Application No.: 10/627,833
Amendment dated: 06/27/2005

Reply to Office action of 04/07/2005

## REMARKS/ARGUMENTS

Fig.7

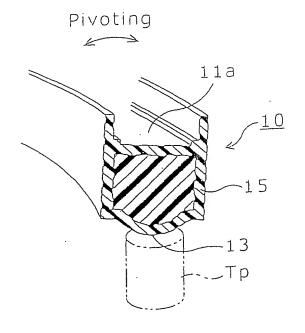
Claim 1, as amended, incorporates the convex, arc-shaped transverse cross-section of the plunger-contacting portion as set forth in canceled claim 5. This feature is depicted in FIG. 7, and discussed in paragraph 0047. With the plungercontacting portion shaped as shown in FIG. 7, even if the slide rail 11 becomes slightly inclined in the direction of the width of the guide, the plunger-contacting portion 13 stably receives the plunger Tp and always contacts the axial center of the plunger Tp. As a result, stable travel of the transmission chain in the direction of the width of the guide can be ensured without generating the biased contact condition shown at X in Fig. 8. Neither Biedermann, nor any of the other cited references of record, discloses or suggests a convex, arc-shaped transverse cross-section in a the plungercontacting portion. Therefore, the prior art does no demonstrate that it would have been obvious to one skilled in
